TECHNICAL NOTE - LIGHTING

SUBJECT: ADDENDUM TO TECHNICAL REPORT ON LIGHTING DESIGN AT FORMER JOHN LEWIS DEPOT, LETCOMBE STREET, READING [3339-DFL-ELG-XX-RP-EO-13001-S3-P04]

Highway Authority Comments and Responses

Figure 3: Columns locations and specifications.

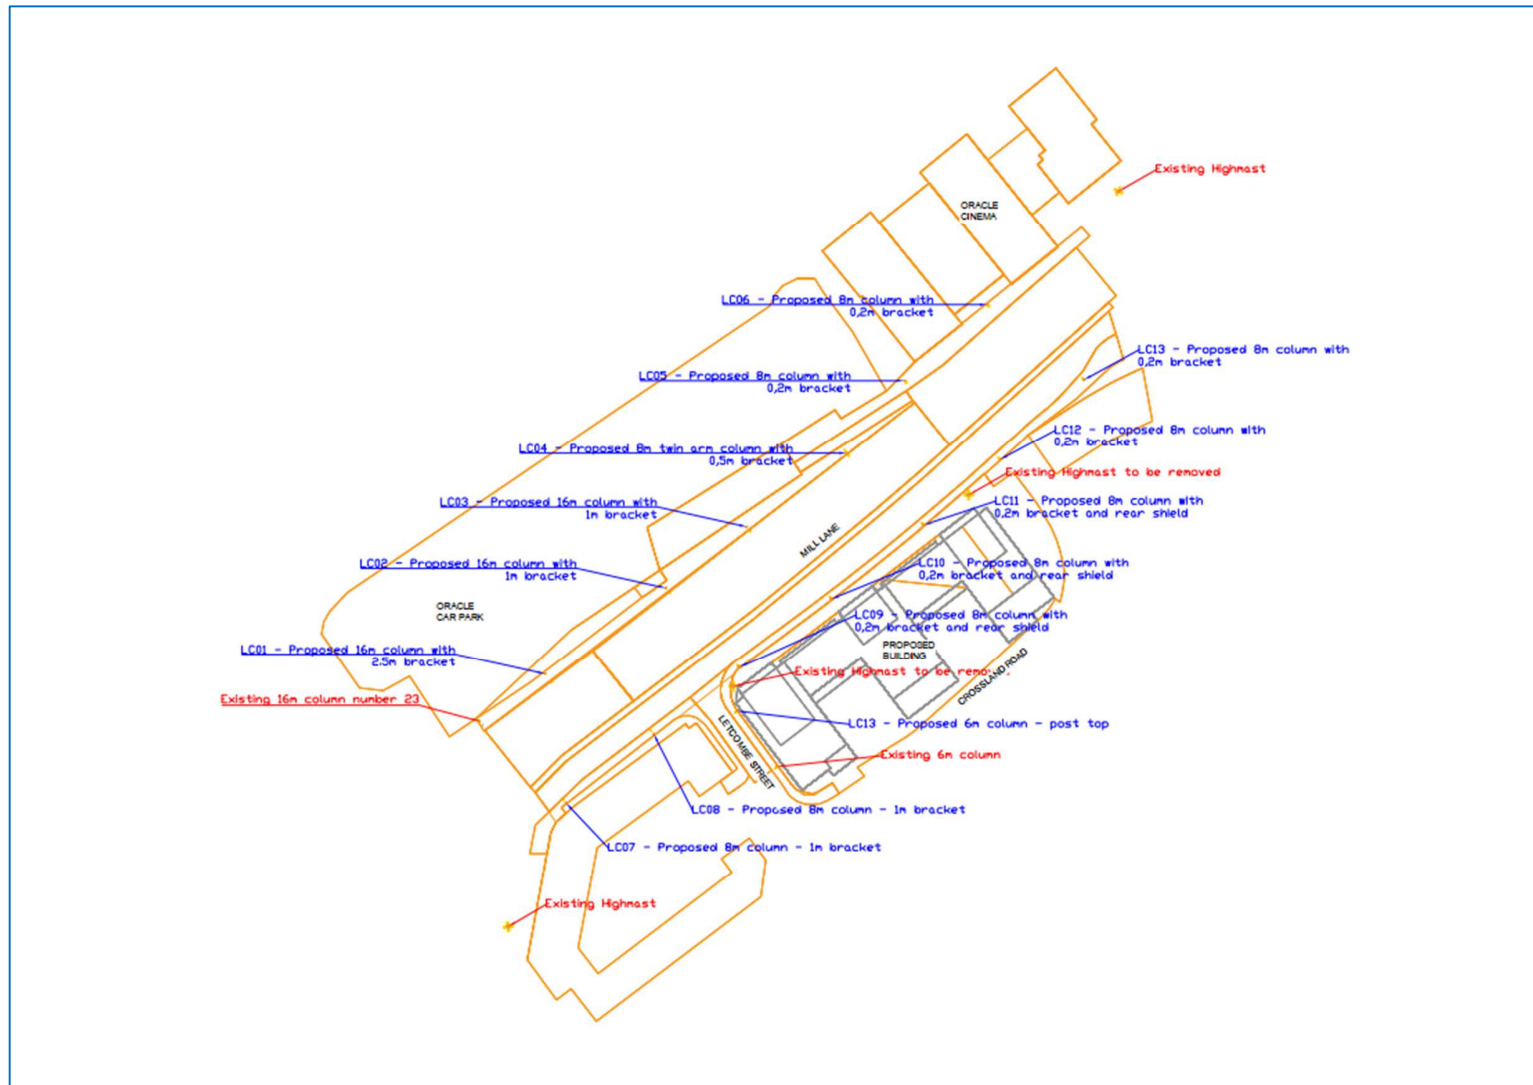
Following a survey by DFL, the first existing column adjacent to the roundabout [numbered on site as 23] has been approximated at 16m height. This has informed our 3D modelling and revised lighting solution. The gap in land ownership necessitates strategic placement of lighting columns: the first proposed 16m column [LC01] is located approximately 23.5m from the existing column, with subsequent columns at intervals of approximately 43m [LC02] and 29m [LC03], respectively. A 2.5m bracket is required on the first column [LC01], and a 1.0m bracket on subsequent columns [LC02 & LC03]. Next to the east an 8m column [LC04] will require 0.5m twin arm bracket. Two 8m columns [LC05 & LC06] in front of the cinema will be equipped with 0.2m brackets allowing for the installation of rear shields if deemed needed. On the opposite side of the road starting from the west, two 8m columns [LC07 & LC08] with 1m brackets are required in front of the hotel. Three 8m columns [LC09, LC10 & LC11] in front of the proposed residential building at the site of the former John Lewis Depot will have 0.2m brackets equipped with rear shields to minimise rear spill light effectively. Further to the east two 8m columns [LC12 & LC13] will be equipped with 0.2m stub brackets to allow for the installation of rear shields on these brackets if deemed necessary. Additionally, on Letcombe Street 6m post top column [LC13] is required to compensate the removal of the high mast. Please refer to the **Appendix B**.

Following a visual survey on site, which included photographs and video footage conducted by DFL, it has been determined that the gap between the elevated roadway and the Oracle building is approximately 1.0m. This gap is sufficient for the installation proposed columns LC01 & LC02. The luminaires mounted on the 16m columns will be maintained by a MEWP from the elevated road. Please refer to **Appendix B**.

Question: *"The Highway Authority does not agree with the proposed street lighting design given that 16m columns will still create maintenance issues for the Council, as standard MEWPS go to 12m/15m, The Highway Authority requests that the proposed lighting design is revised utilising 12m columns instead of the proposed 16m, which may in turn result in some of the proposed 8m columns needing to be 10 or 12m instead.*

Further to this I provide a copy of the Highway Extent along the Oracle boundary and the IDR which identifies that not all of the land is in fact adopted Highway that would limit the locations for columns as well as images of The Oracle car park elevation which includes lighting and support cables and protruding arched metal structures along its length which will make siting any columns along this elevation extremely difficult at best."

Answer: Based on the 3D modelling analysis, it is determined that 16m columns are necessary to achieve the required lighting levels, particularly with regard to uniformity over the overpass. The placement of 8m columns on the opposite side of the road remains essential to ensure that the lighting levels for the specified lighting class are achieved. Given the height of the overpass, utilising columns below 16m would result in the light source being positioned too low relative to the carriageway, which would be problematic both in terms of lighting levels and physical clearance. Please refer to the addendum section titled **"REVISED COLUMN HEIGHTS AND FEASIBILITY"** for further details.

We have also conducted a thorough review of the provided Highway Extent documentation and have successfully arranged the 16m columns at suitable intervals to mitigate any potential land ownership conflicts. For more information, please see the addendum section **"COLUMN HEIGHTS AND LAND OWNERSHIP."**

Answer: Based on the site survey conducted by DFL and the accompanying documentation outlining the parameters of the adoptable land, we can confirm that the proposed solution effectively addresses both identified constraints. The placement of columns can be optimised in accordance with the guidelines specified in **"COLUMN HEIGHTS AND LAND OWNERSHIP"** and **"THE ORACLE BUILDING CONSTRAINTS"** included in the addendum.
